MEMORANDUM

RE: Response to Noise Peer Review Comments
Proposed Residential Development
9229 5th Sideroad, Caledon
Caratania Investments

Valcoustics Canada Ltd. prepared an Environmental Noise Analysis report, dated January 22, 2021, in support of the above noted residential development. The report was peer reviewed by Thornton Tomasetti on behalf of the Town of Caledon. This memorandum has been prepared to address the peer review comments.

Title
Sound Barrier

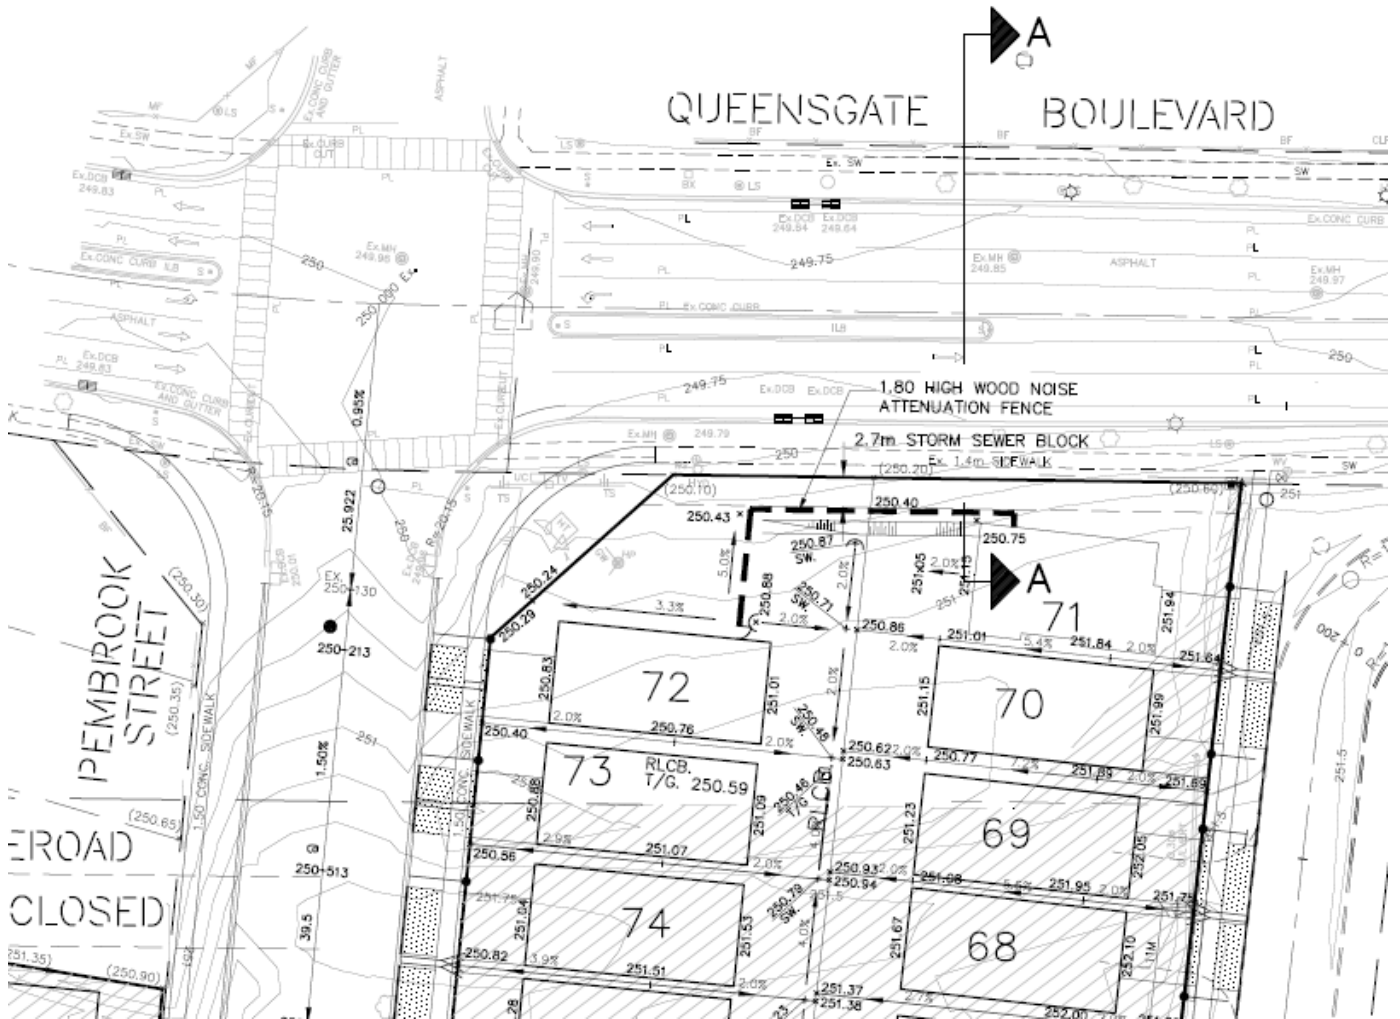
1. To complete the noise study, the higher of the traffic volumes on Queensgate Boulevard to the east and west of Landsbridge Street was used. As noted in the peer review, this was done to be conservative by ensuring the sound levels due to road traffic were not underpredicted at the proposed development.
2. The peer review has requested additional detail be provided regarding the extent of sound barrier required to protect the impacted Outdoor Living Areas (OLAs). As correctly noted in the peer review letter, the sound barrier must provide appropriate protection for the OLA by either returning to the dwellings themselves or extending an appropriate length to create a proper overlap. The report recommends a 1.8 m high sound barrier for Lot 56 and part Block 72. The recommended barrier was shown conceptually on Figure 2 of the report.

Figure 1 of this memorandum is from the Preliminary Grading Plan (prepared by Rand Engineering, dated February 2021) and shows the recommended 1.8 m high sound barrier at Lots 71 and 72 (part Block 72 and Lot 56, respectively, in our noise report). The sound barrier is shown returning to the north dwelling facades. This is considered appropriate and provides full acoustical screening of the OLAs from traffic noise generated on Queensgate Boulevard.

The alternative to returning the sound barrier to the dwelling facades would be to extend it along the north property line towards the fronts of the dwellings. The barrier would need to extend beyond the rear corner of the dwelling a distance at least 3 times the size of the gap between the barrier and the dwelling.

The final sound barrier and grading design should be reviewed to ensure the sound barrier height and extent are adequate to meet the Town of Caledon daytime sound level objectives in the OLA.
